JOINT PUBLIC HEARING
THE CITY COUNCIL AND THE PLANNING AND ZONING COMMISSION OF THE
CITY OF PEARLAND, TEXAS,
MONDAY, JULY 21, 2014, AT 6:30 P.M.
COUNCIL CHAMBERS - CITY HALL-3519 LIBERTY DRIVE

Zone Change Application No. 2014-11Z

Re: Zone Change Application Number 2014-11Z

Zone Change Application No. 2014-10Z

Exhibit D
Design Plan

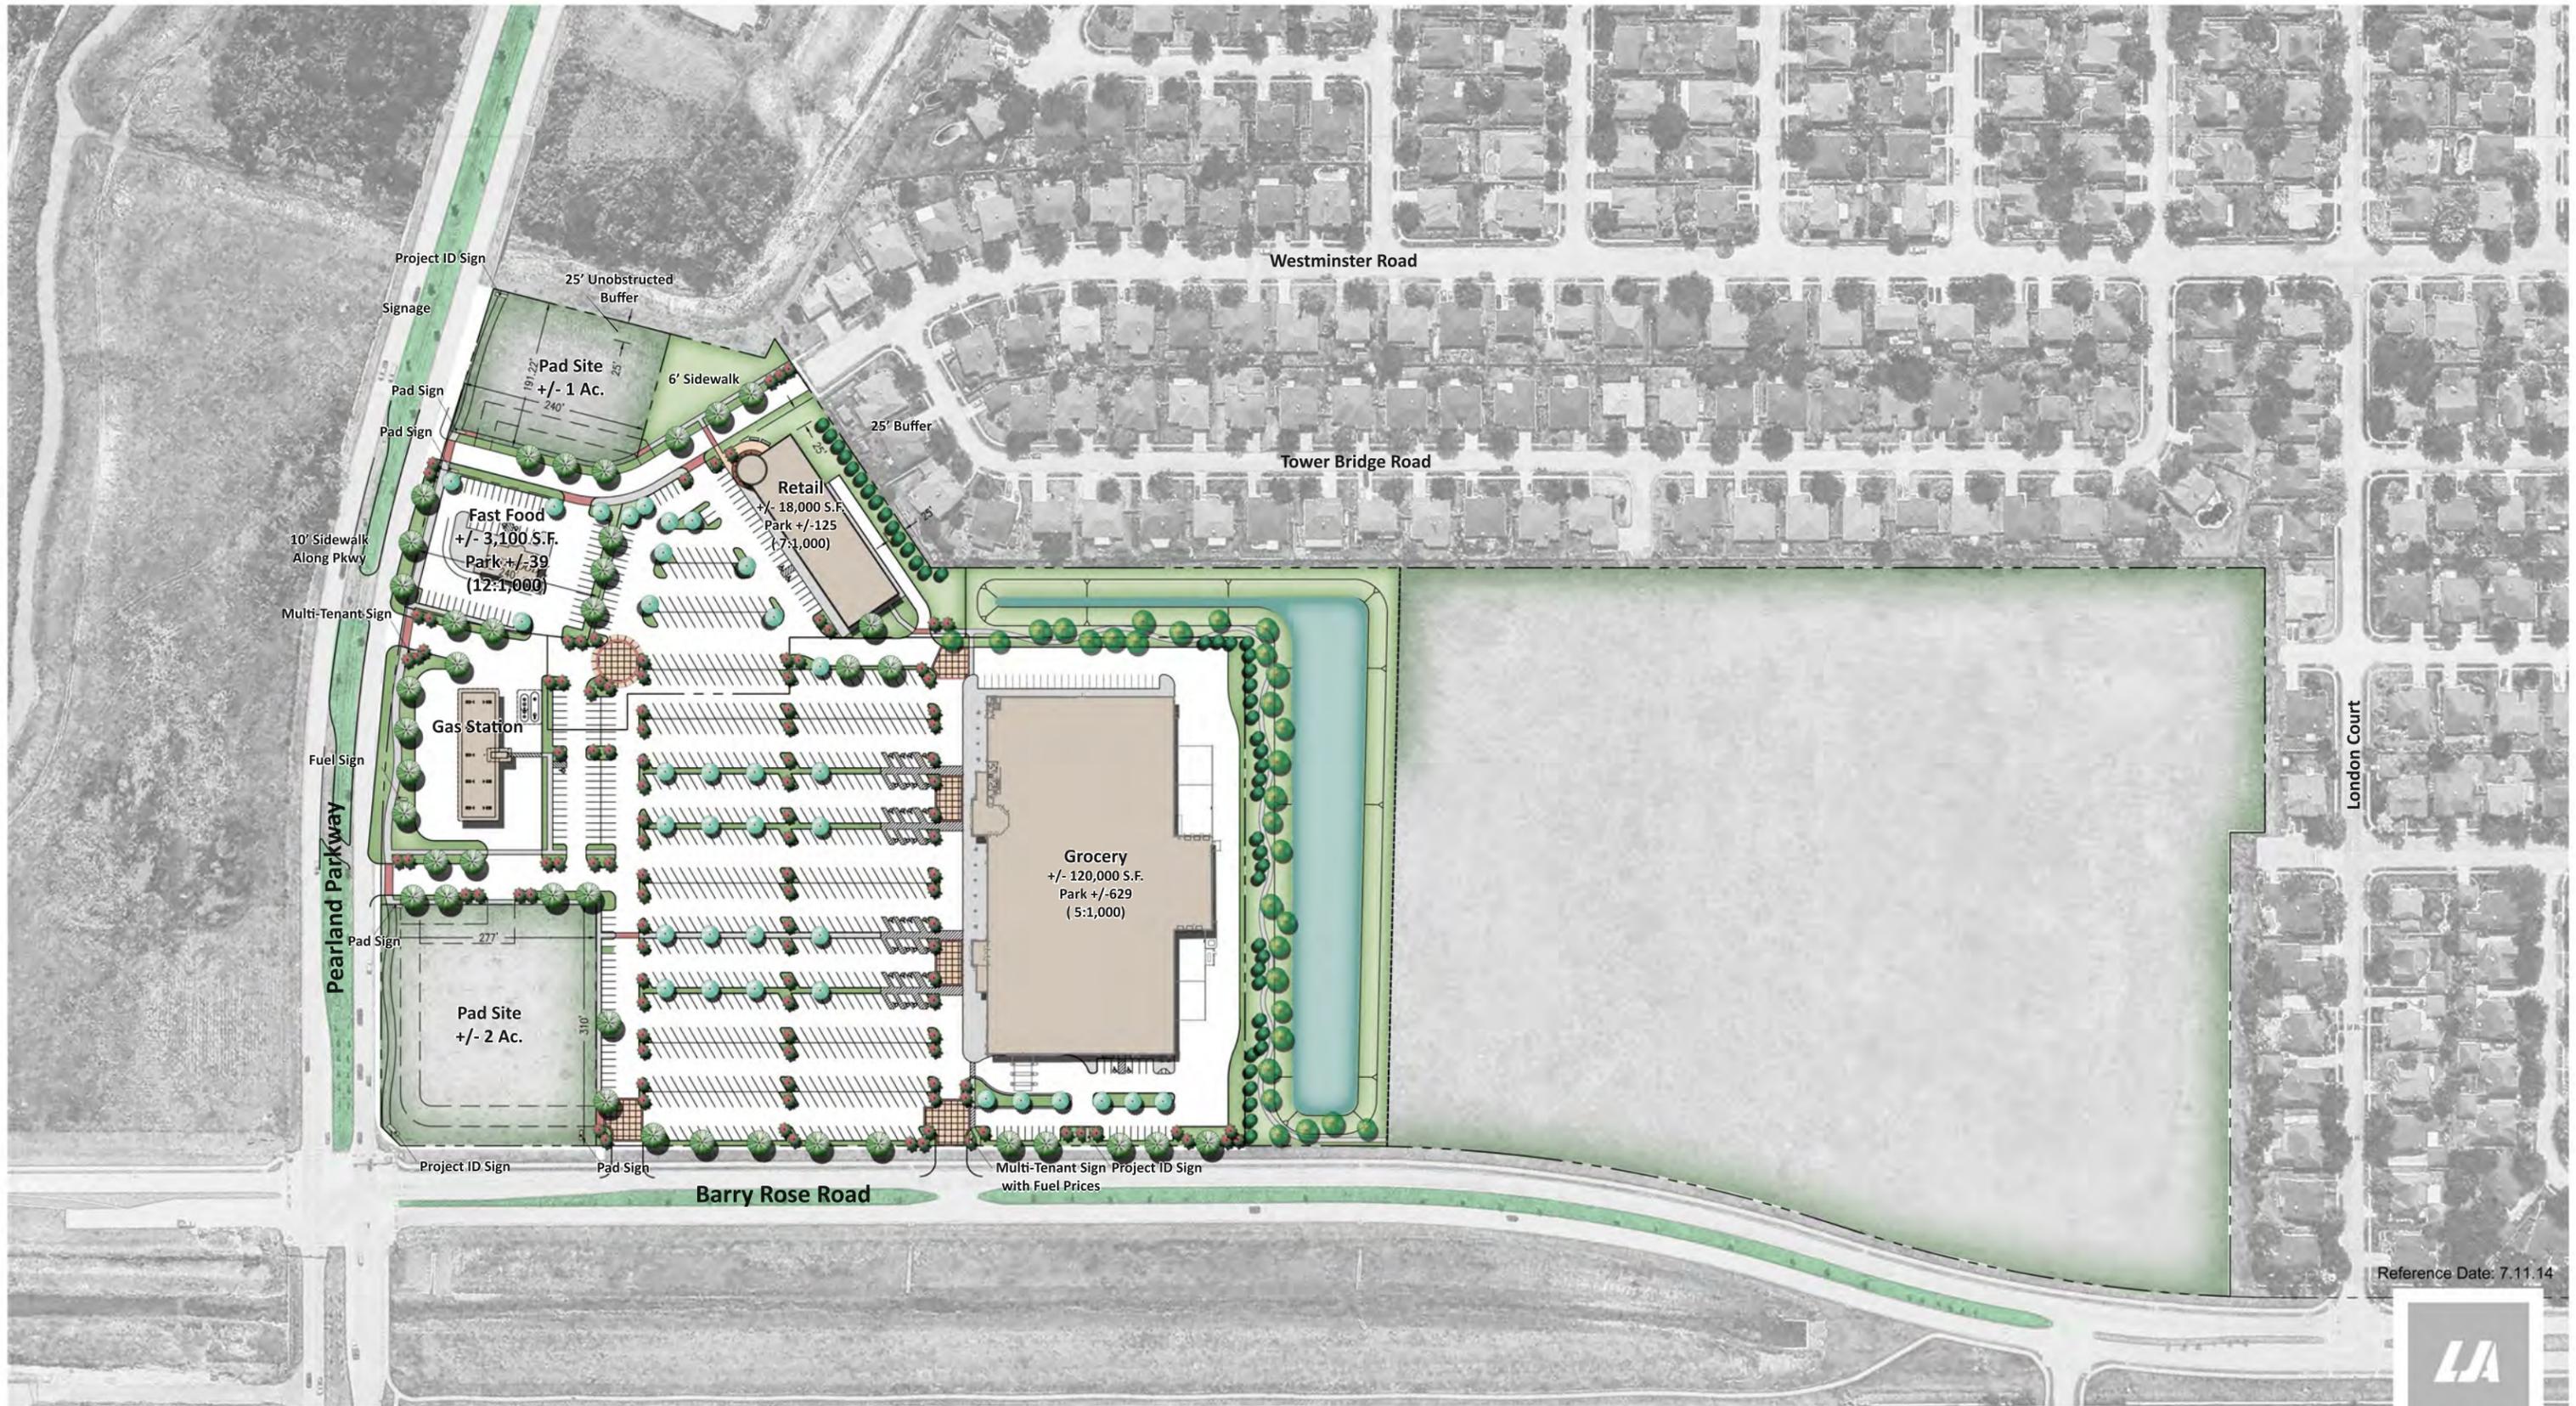
- North arrow needs to be corrected.
- Page numbers within the PD document are off.
- Codification of enhancements that are mentioned throughout the PD and illustrated in the design plan, Exhibit E (Special Paving Images) and Exhibit G (Site Furnishings) to ensure that staff is able to implement the design standards.

- A legend should be included on the design plan to ensure that staff can implement the standards.
- Clarification of the lighting standards is required. The PD states that the lighting height will be a maximum of 20 feet. This section goes on to state that no pole shall be taller than the height of the building.

7. A legend should be included on the design plan to ensure that staff can implement the standards.
8. Clarification of the lighting standards is required. The PD states that the lighting height will be a maximum of 20 feet. This section goes on to state that no pole
